# CARNBUCK WIND FARM

## Further Environmental Information 2025

### Volume 1 - Non-Technical Summary

This Further Environmental Information (FEI) 2025 has been prepared in support of the planning application for the proposed Carnbuck Wind Farm, planning reference SPD/2023/0951/F. The proposed wind farm is located approximately 4.4km north east of Cloughmills and approximately 12 km south west of Cushendall in the townlands of Carnbuck, Magheraboy and Moneyneagh, east of Corkey Village. The planning application was validated in March 2023.

**Illustration 2. Zoom in of Figure 1.2 Planning Application Boundary showing locations of ANT013:010/ ANT 013:089 in relation to proposed road widening (Detail 1). Location of ANT013:021 is also shown.**

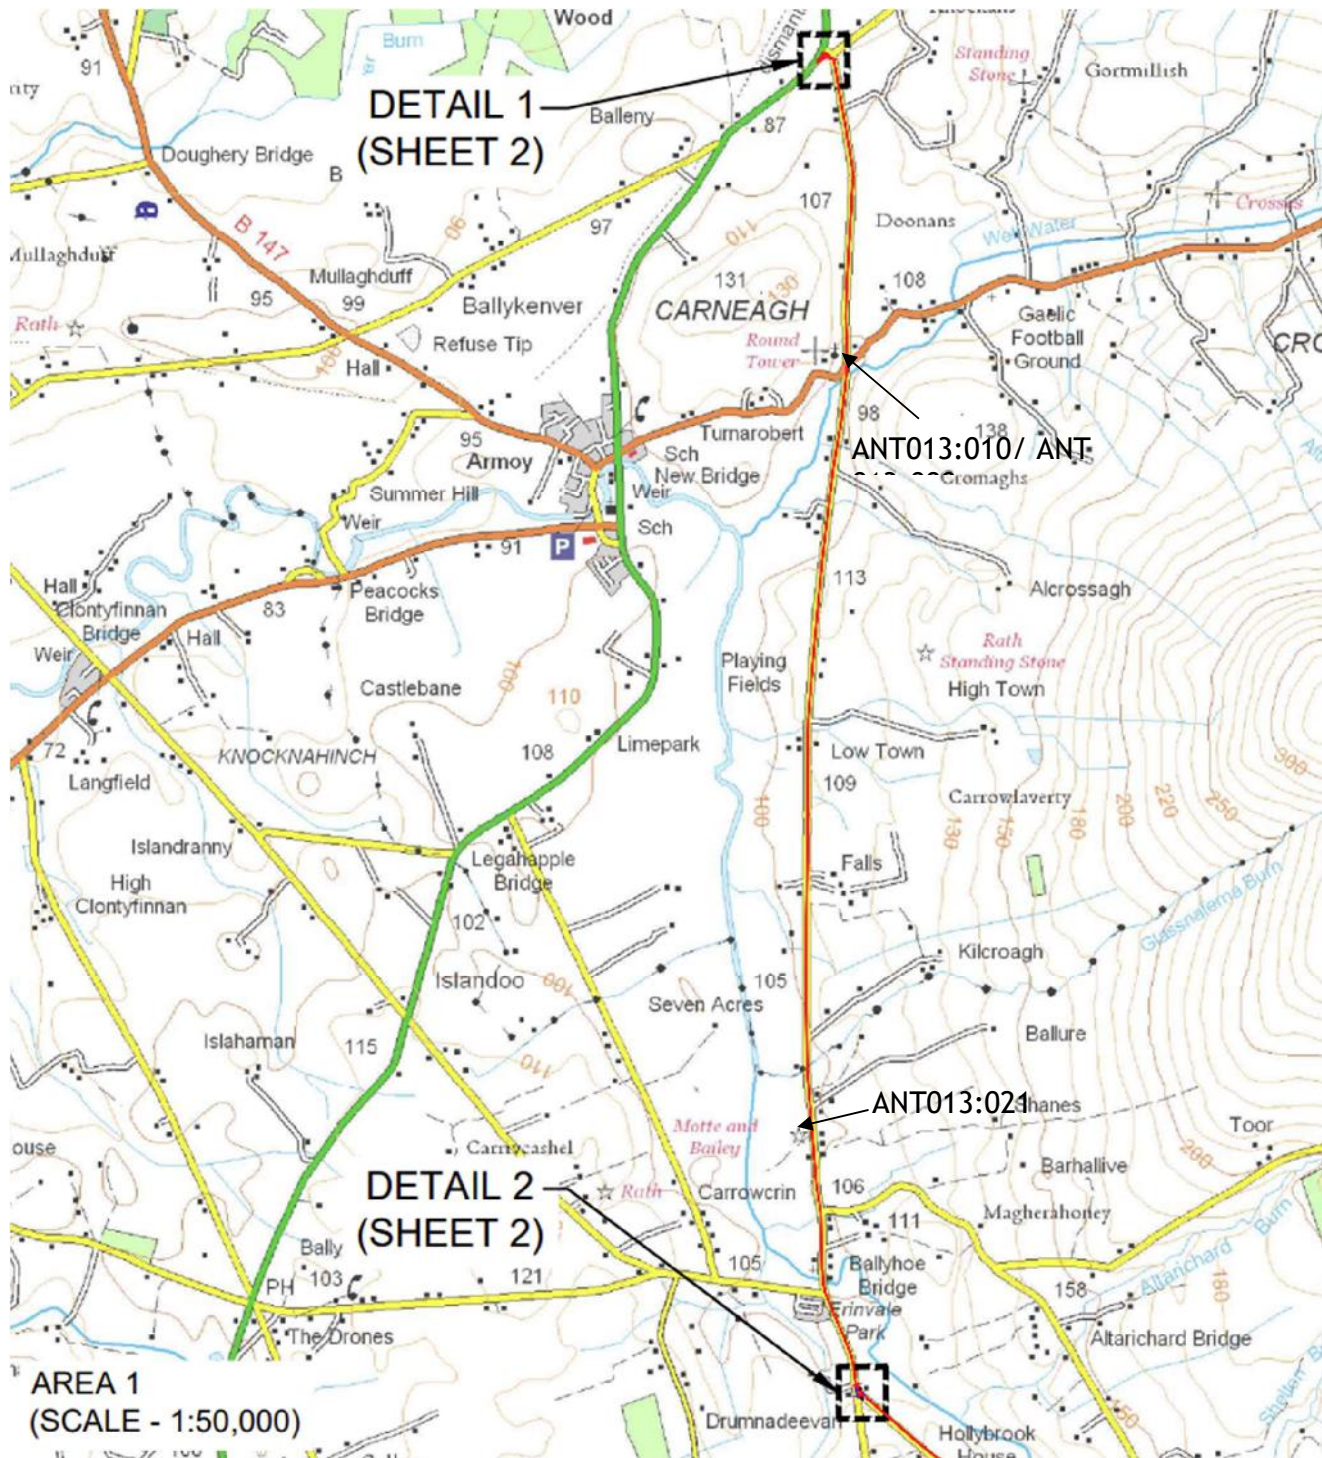
- 8.46 HED: HM stated:  
'An important potential impact along the proposed access route has been missed in the Archaeology and Cultural Heritage Chapter. Detail 1 of Fig 1.2 - Planning Application Boundary indicates an area of road widening which is immediately adjacent to Armoys scheduled and state care round tower and ecclesiastical site ANT013:010 and the scheduled earthwork ANT 013:089. HED (Historic Monuments) would have concerns about the impact of the utilisation and widening of the existing route in its context immediately next to these two significant scheduled sites. There is a clear possibility of a much wider ecclesiastical settlement associated with the round tower which could be impacted by the road widening. There is no identification or assessment of this potential impact nor are there any proposals for mitigation included in the Chapter or Technical Appendix and this would need specific consideration and mitigation proposals in the programme of works. Also it should be considered that any road widening along the route could potentially have an impact on other monuments including Doonavernon motte and bailey ANT 013:021 whose scheduled area is located right up to the edge of the road.'

- 8.47 There seems to be a misunderstanding on HED: HM's part regarding the location of Detail 1 of Figure 1.2 - Planning Application Boundary. This part of the proposed access route is located approximately 1.5 km north of the location of Armoys

scheduled and state care round tower and ecclesiastical site ANT013:010 and the scheduled earthwork ANT 013:089. Illus 2 below is an extract of Figure 1.2 - Planning Application Boundary which shows the locations of ANT013:010 and ANT 013:089 marked. Doonavernon motte and bailey ANT 013:021 also does not lie within an area of the proposed access route where any road widening is proposed (Illus 2).

**Drawing 8.1 (page 1/2)**

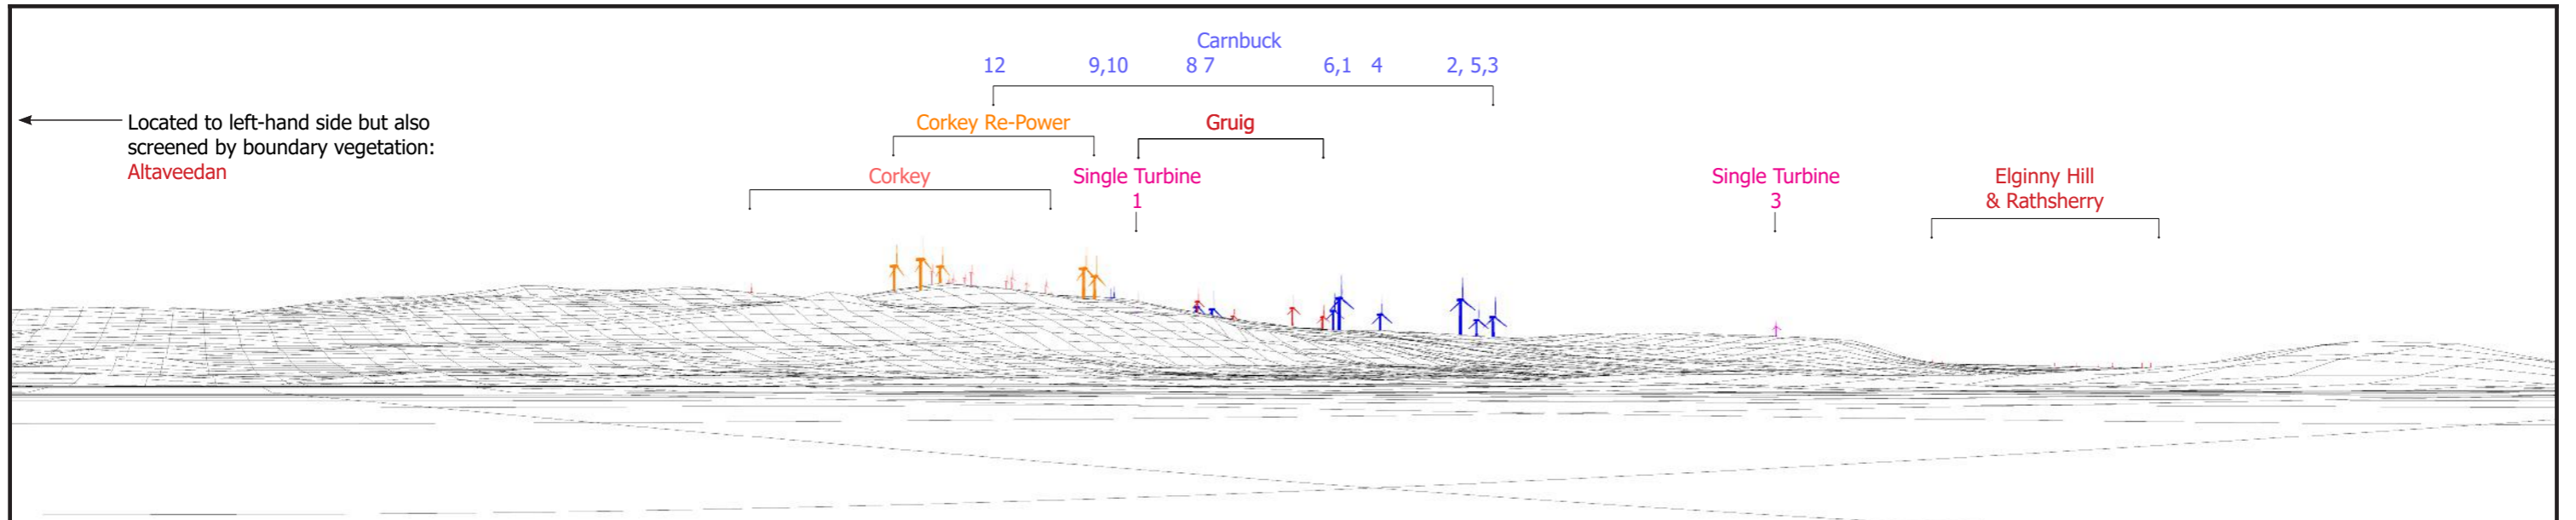
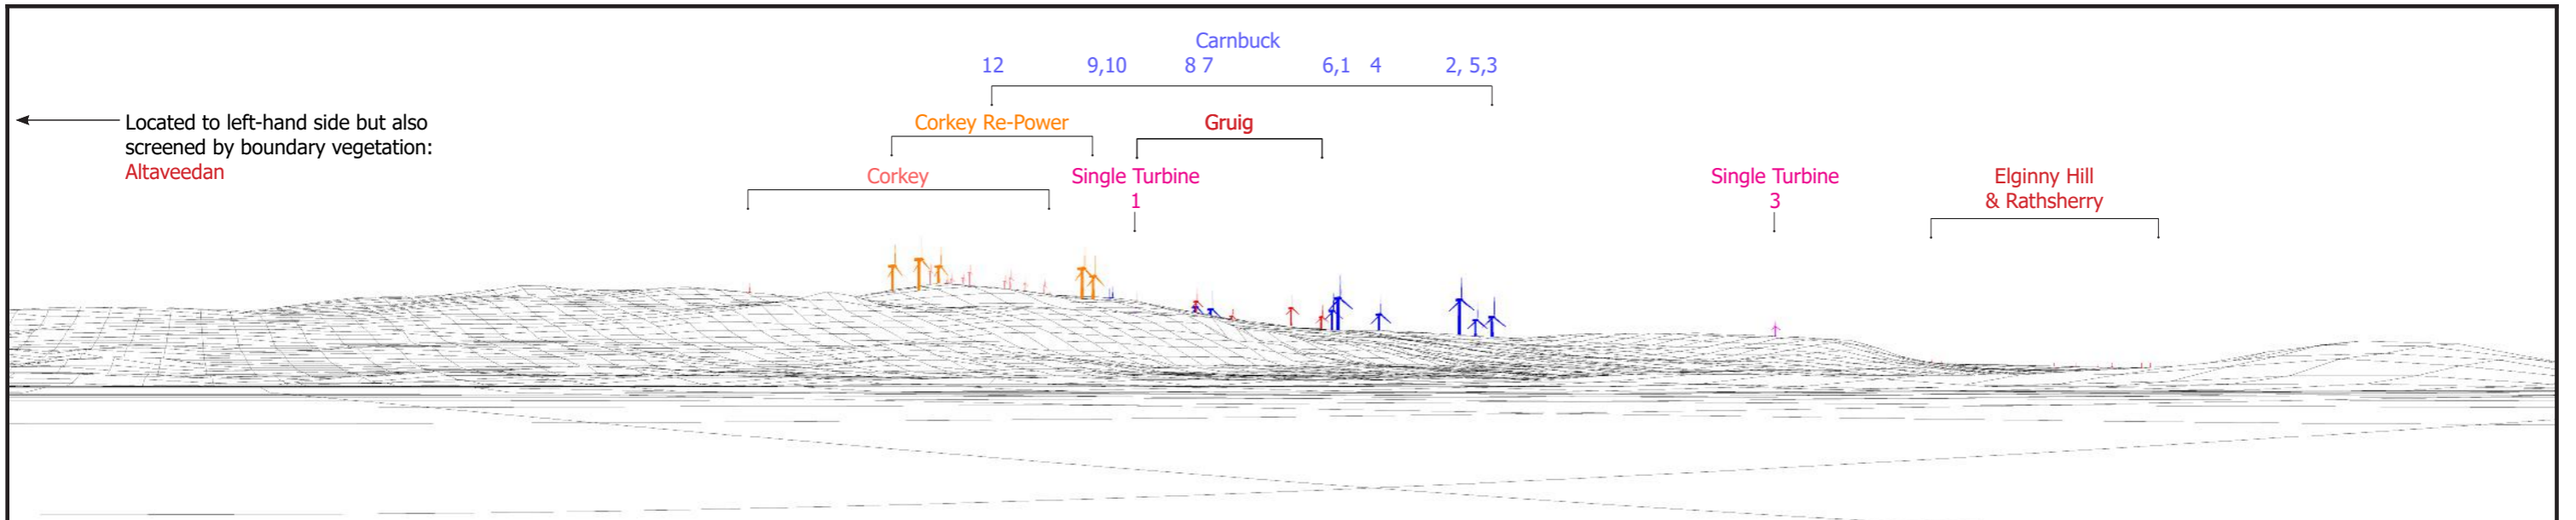
- 8.8 The methodology employed for assessment of potential impacts remains unchanged from that used in the ES (described in ES paragraphs 8.39 - 8.77).
- 8.9 In response to HED: HM's requests for additional photomontages for Lissanoure demesne (AN/049), three photomontages have been produced. New photography was taken from three locations within Lissanoure demesne (AN/049):
- Viewpoint 1 (Figure 8.1): 306495, 424220 (shore of Lough Guile, marked by a bench)
  - Viewpoint 2 (Figure 8.2): 306598, 424348 (front of Lissanoure Castle (ANT018:011))
  - Viewpoint 3 (Figure 8.3): 306471, 424592 (from ground looking towards Lissanoure Castle (ANT018:011)) at north-west of pond)
- 8.10 The viewpoint locations are shown in Figure 8.4.

- 8.41 Viewpoints 1 (Figure 8.1) and 2 (Figure 8.2) demonstrate that from the northern shore of Lough Guile and from south of Lissanoure Castle (ANT018:011), policy woodland would screen any views of proposed turbines from these locations.
